ADDENDUM NO. 09
10 June 2009

Project: **THE NEW TEXAS CITY HIGH SCHOOL**
Texas City Independent School District

Issued by: **Bay Architects, Inc.**
18201 Gulf Freeway
Webster, TX 77598
281-286-6605

Bay Project No.: **0748**

ADD-09-01
 0714
 1/8" = 1'-0"
 June 9, 2009
 M2.14

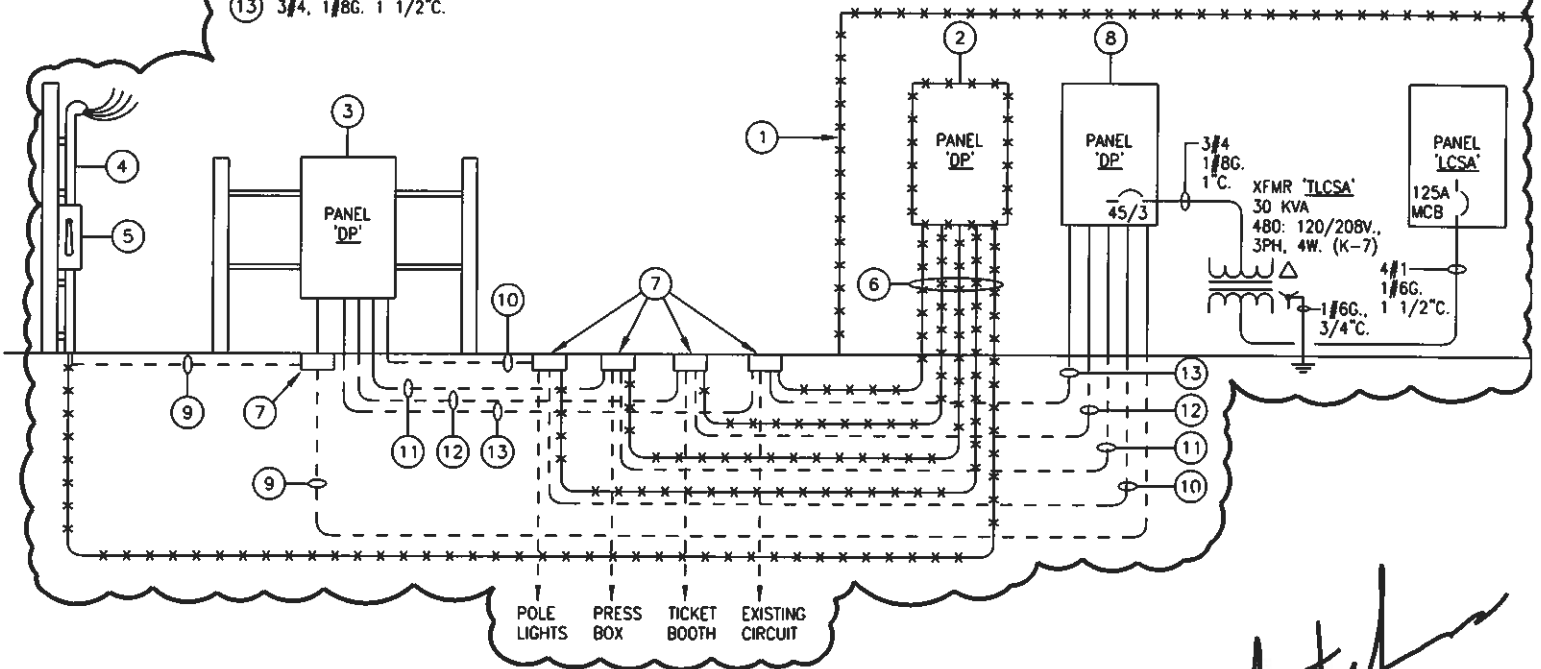
b. See sketch **ADD-09-01** for revisions to Mech.E202.
c. Provide 24/14 transfer duct with smoke damper into corridor for following science rooms: E215, E206, E215, E219.

ADD-09-02

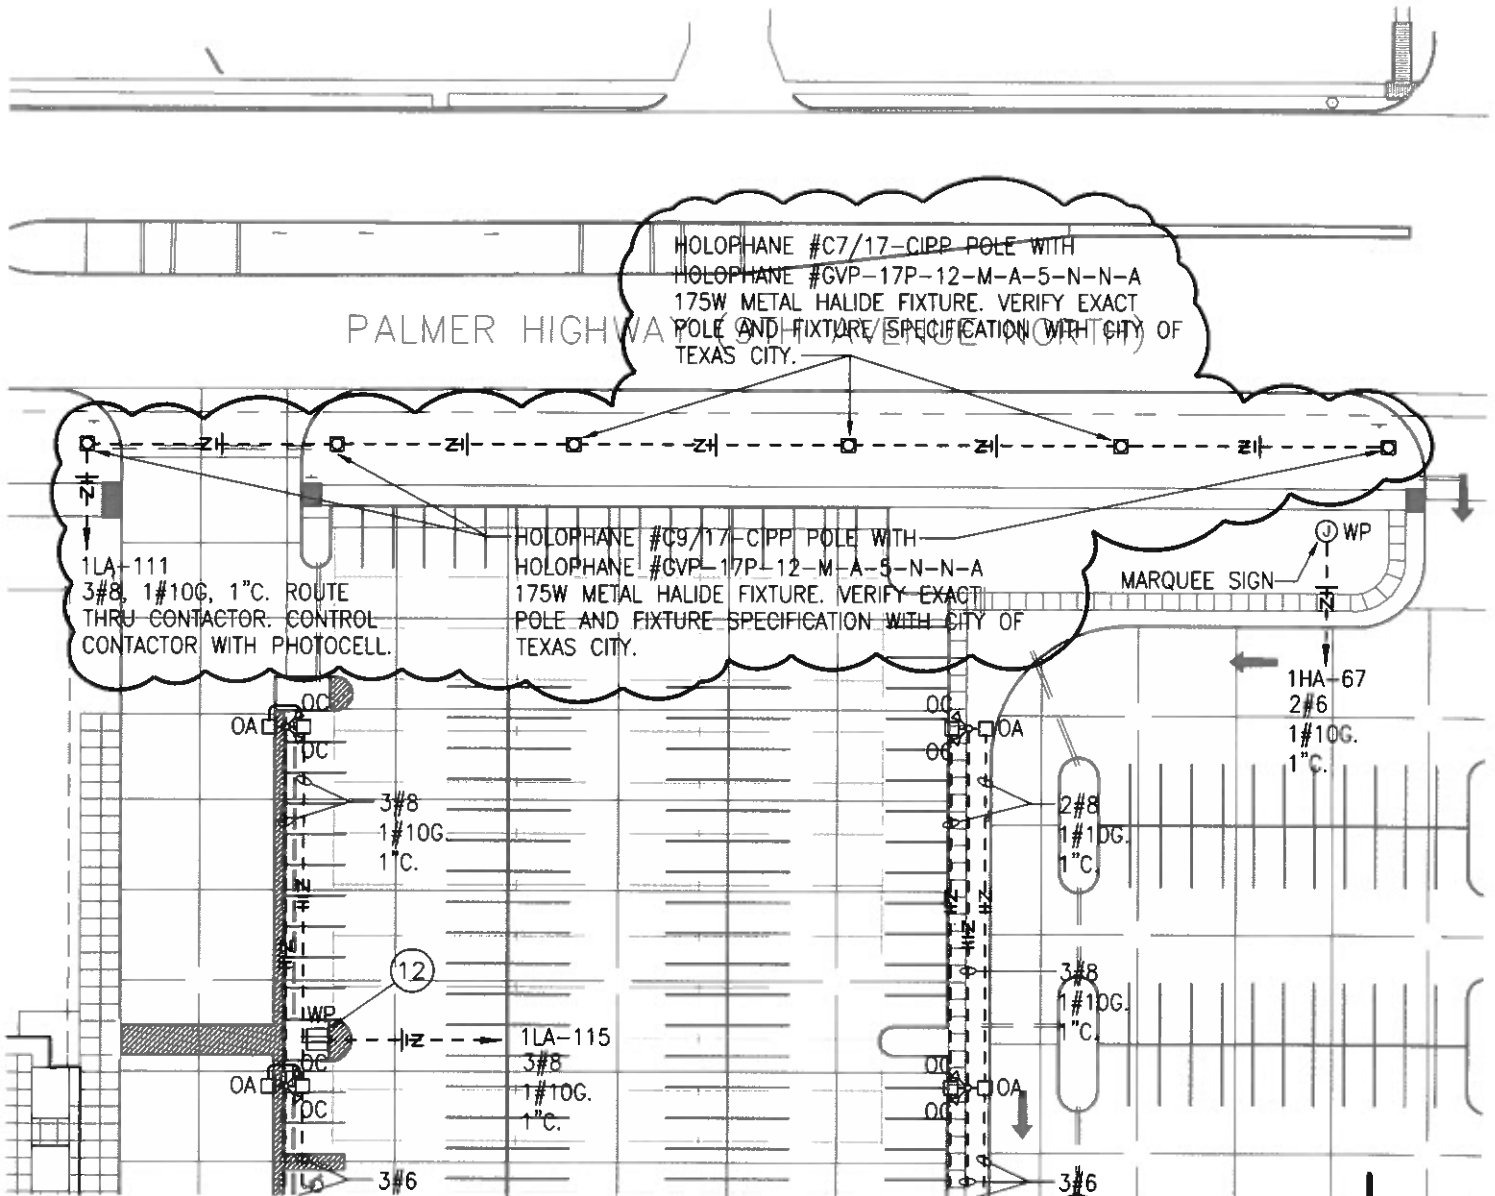
22. Sheet E1.01 – Electrical Partial Site Plan
 - a. Refer to attached Sketch **ADD-09-02** for revised electrical service to visitors’ side concession building.
 - b. Refer to attached Sketches **ADD-09-03** and **ADD-09-04** for additional street lighting.

- 1 EXISTING CONCESSION BUILDING TO BE REMOVED.
- 2 EXISTING 600A DISTRIBUTION PANEL 'DP' TO BE REMOVED. ALL EXISTING LOADS FROM PANEL 'DP' ARE TO REMAIN ACTIVE DURING CONSTRUCTION.

- 3 PROVIDE NEW 277/480V., 3PH., 4W. 600A NEMA-3R DISTRIBUTION PANEL ON GALVANIZED UNISTRUT RACK. RECIRCUIT ALL EXISTING LOADS FROM DEMOLISHED PANEL 'DP' TO THIS LOCATION. RELOCATE NEW PANEL 'DP' TO INSIDE OF NEW CONCESSIONS BUILDING DURING CONSTRUCTION.

- 4 REMOVE (2) EXISTING 4" WEATHER HEADS AND REPLACE WITH NEW.
- 5 EXISTING 600A DISCONNECT SWITCH TO REMAIN.
- 6 DISCONNECT EXISTING LOADS FROM PANEL 'DP' AND REMOVE BACK TO NEW PULLBOX.

- 7 NEW PULLBOX WITH H2O TRAFFIC DUTY COVERPLATE TO INTERCEPT EXISTING CIRCUITS FROM DEMOLISHED PANEL 'DP'.
- 8 FINAL LOCATION FOR NEW PANEL 'DP' SHALL BE INSIDE THE NEW VISITORS CONCESSION BUILDING AT THE COMPLETION OF CONSTRUCTION.

- 9 (2) 3" C. EACH WITH 4#350KCMIL, 1#1G.
- 10 (4) FOOTBALL FIELD LIGHTING CIRCUITS. (4) 1 1/2" C. EACH WITH 3#4, 1#8G.
- 11 3#8, 1#10G. 1" C.
- 12 4#500KCMIL, 1#3G. 3 1/2" C.

- 13 3#4, 1#8G. 1 1/2" C.
